Steepbank Mine Project

Supplemental Information Response

**SUPPLEMENTAL INFORMATION RESPONSE
STEEPBANK MINE PROJECT
EUB APPLICATION NO. 960439
AEP APPLICATION NO. 020-95, AND FILE NO. 27551**

The following information is provided in response to the Energy and Utilities Board and Alberta Environmental Protection supplemental information request dated July 12, 1996. The following response follows the outline of your supplemental request letter.

Figure 5.5-1

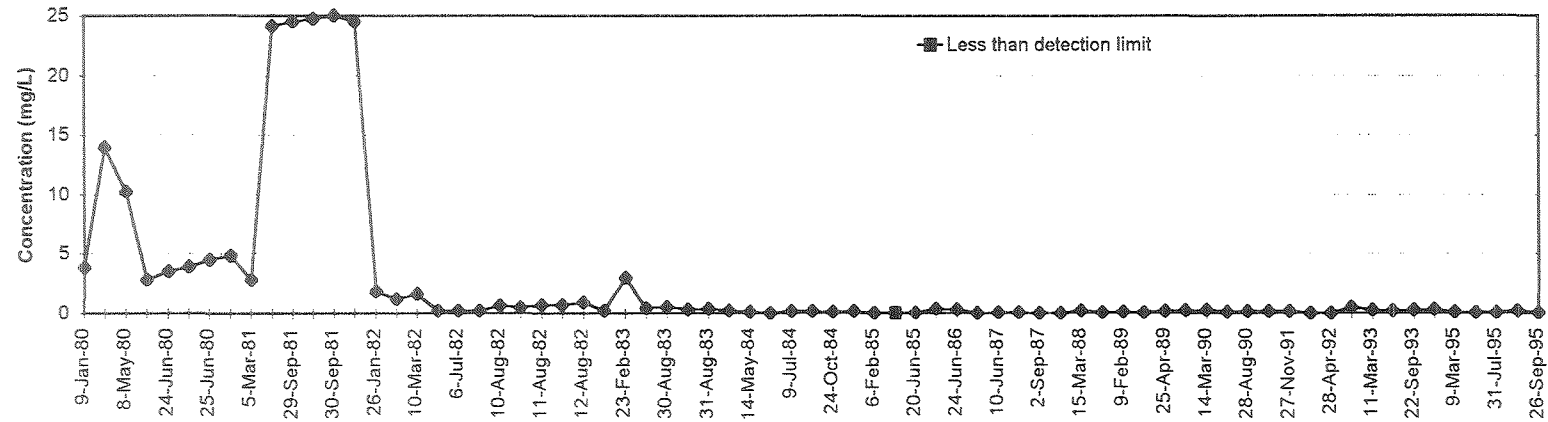
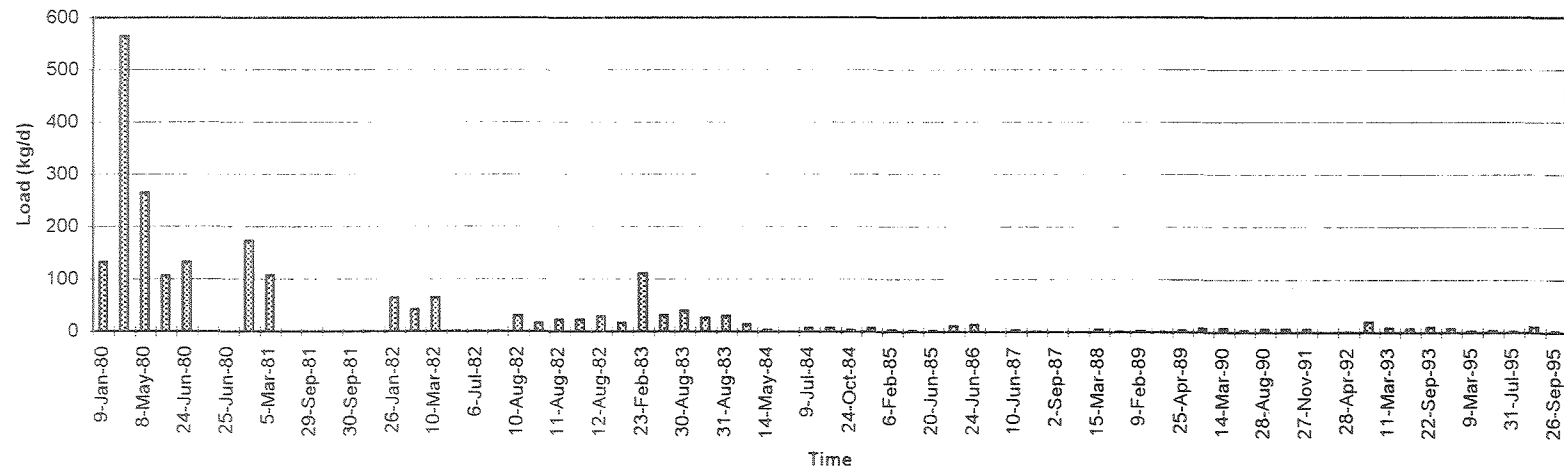
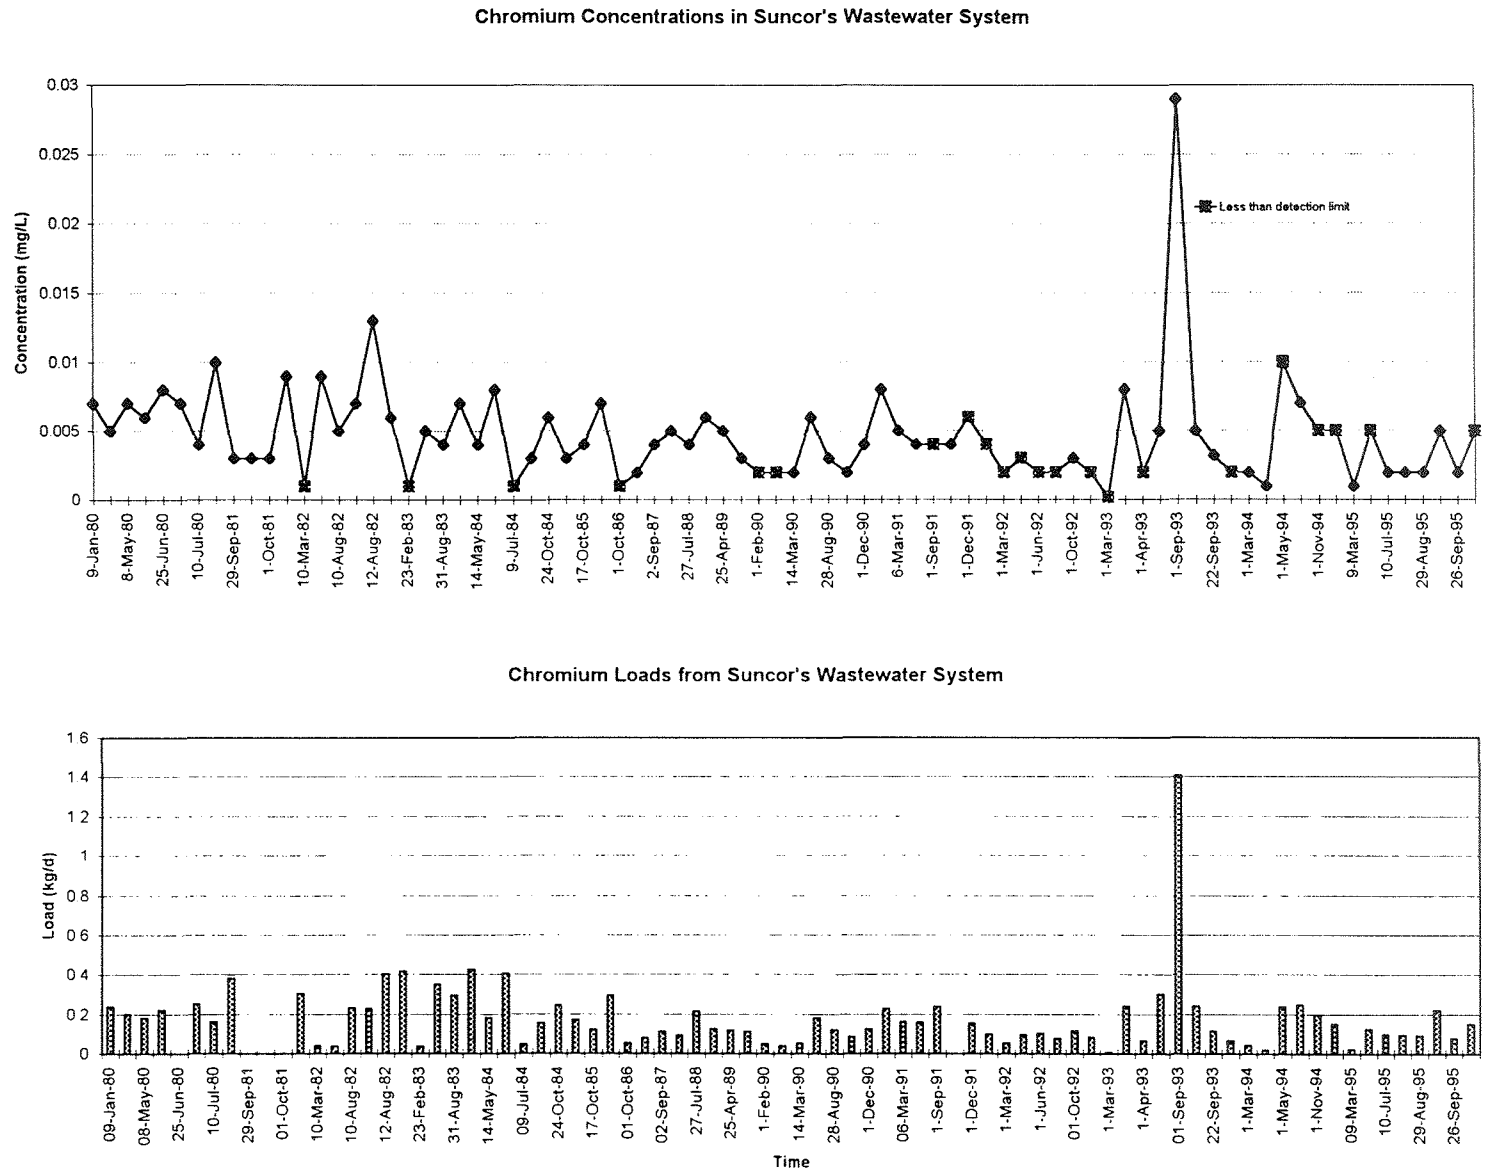
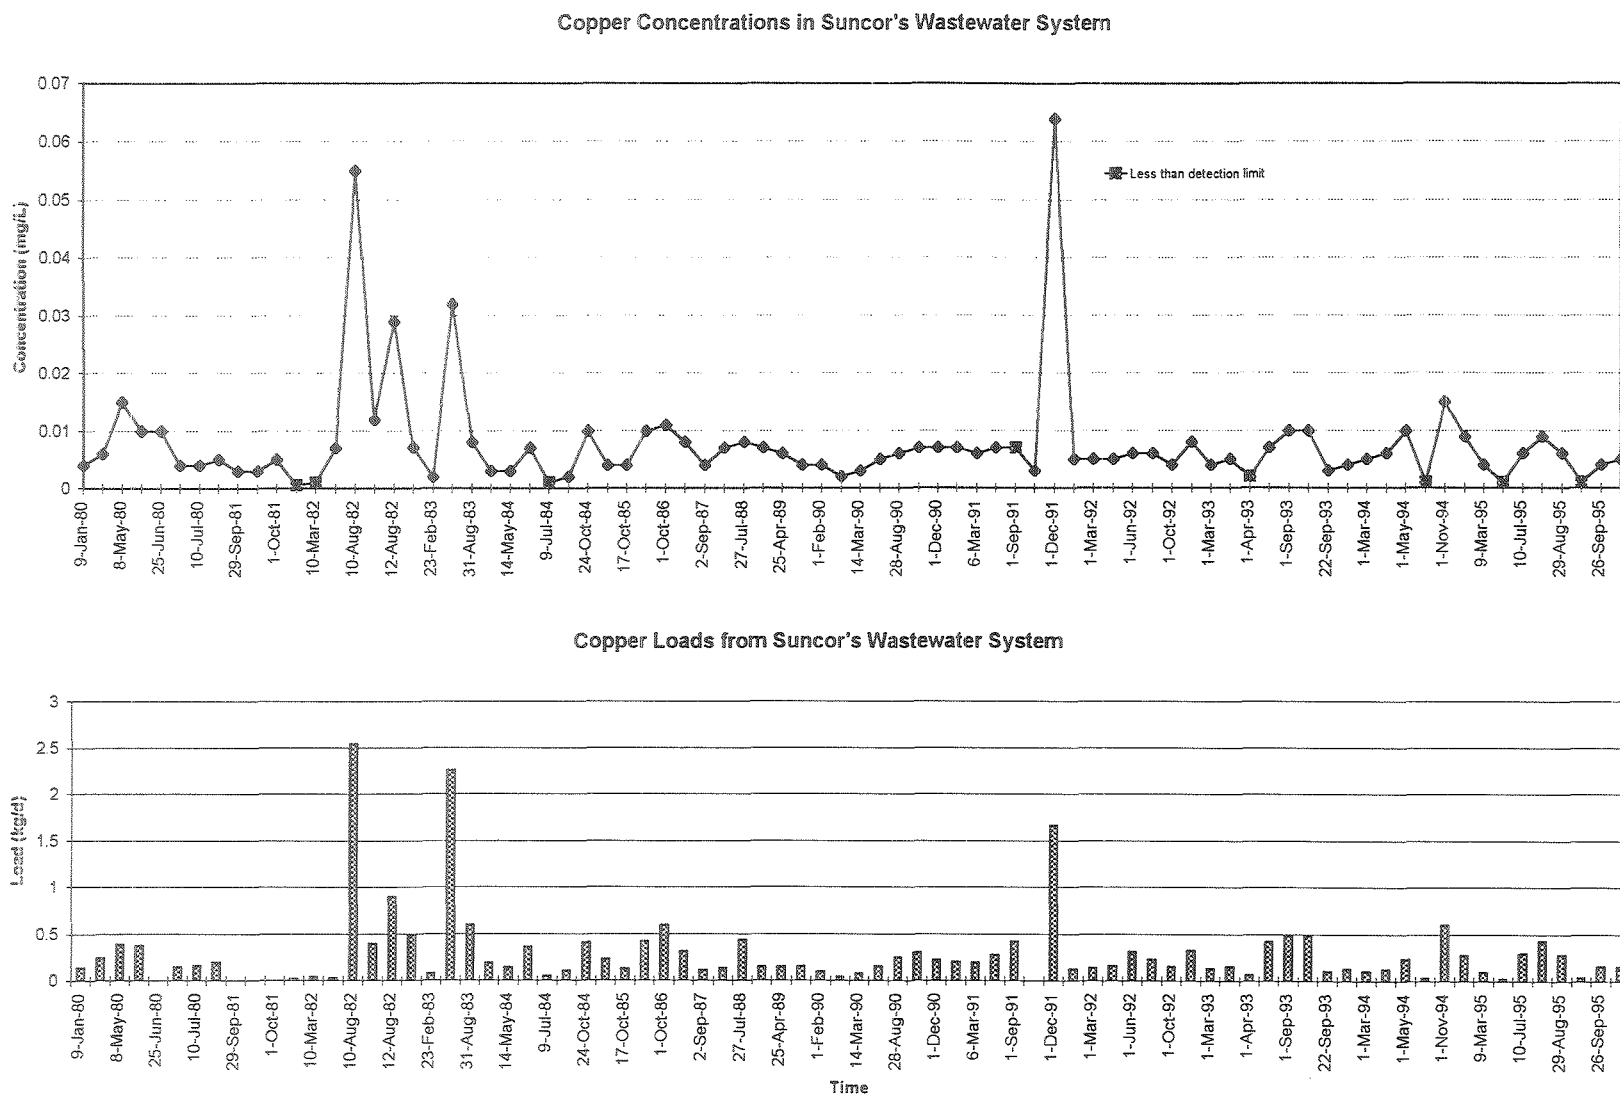
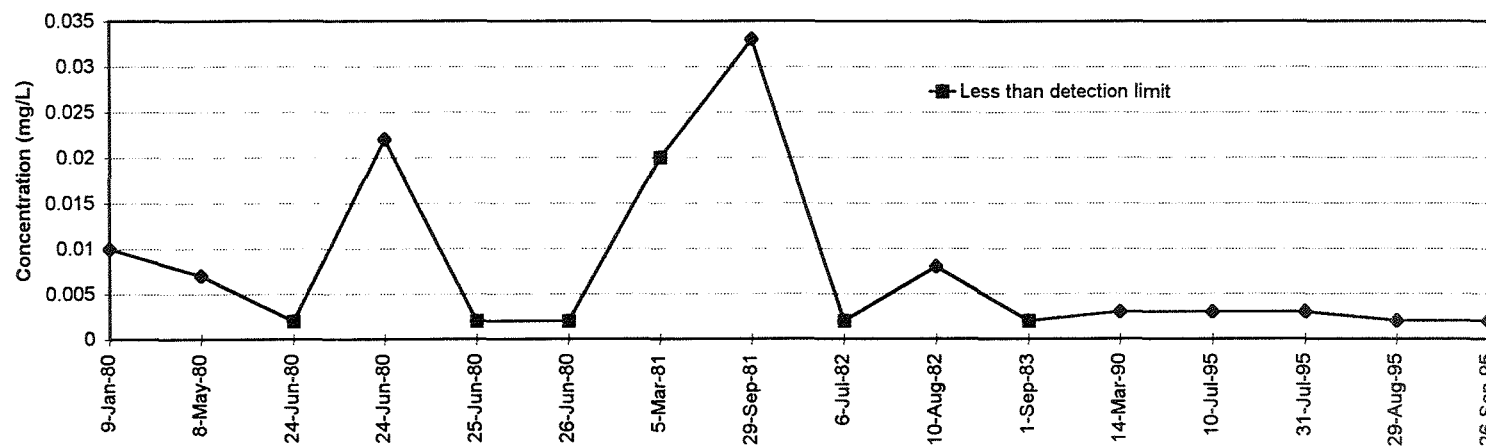
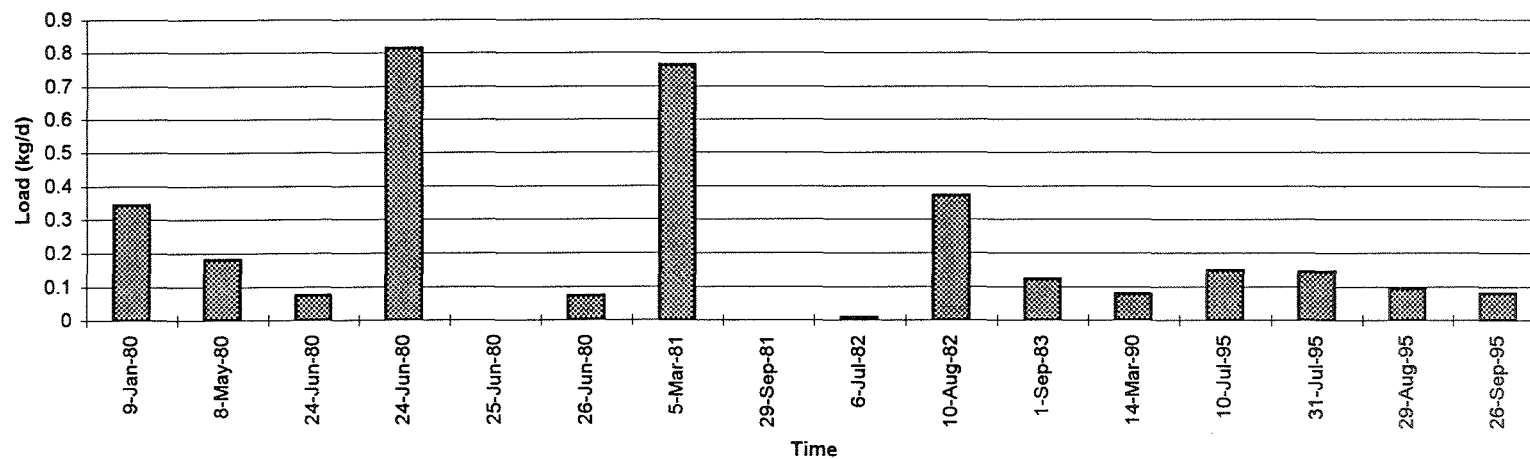
Q5.5 Provide time series graphs of wastewater concentrations/loadings for ammonia, chromium, copper, and cyanide (*Athabasca River Water Releases Impact Assessment, May 1996, p.23*). Table 4.1–3 could not be located as referenced. What plans does Suncor have to monitor these substances in the future?

A5.5 Time series graphs of wastewater concentrations for ammonia, chromium, copper and cyanide are shown in Figures 5.5-1, 5.5-2, 5.5-3 and 5.5-4, respectively. Table 4.1-13 was incorrectly referenced. The correct reference is Table VI-11.

Chromium and copper are monitored quarterly from the wastewater outfall as part of

Suncor's Approval NO. 94-01-00. Ammonia is monitored daily. Cyanide is monitored as part of special studies or investigations. A detailed environmental monitoring program is under development to confirm EIA predictions and to assess potential impacts associated with water releases from Suncor's existing and proposed operations. This program will be developed with stakeholder input and is expected to be finalized by September 30, 1996.
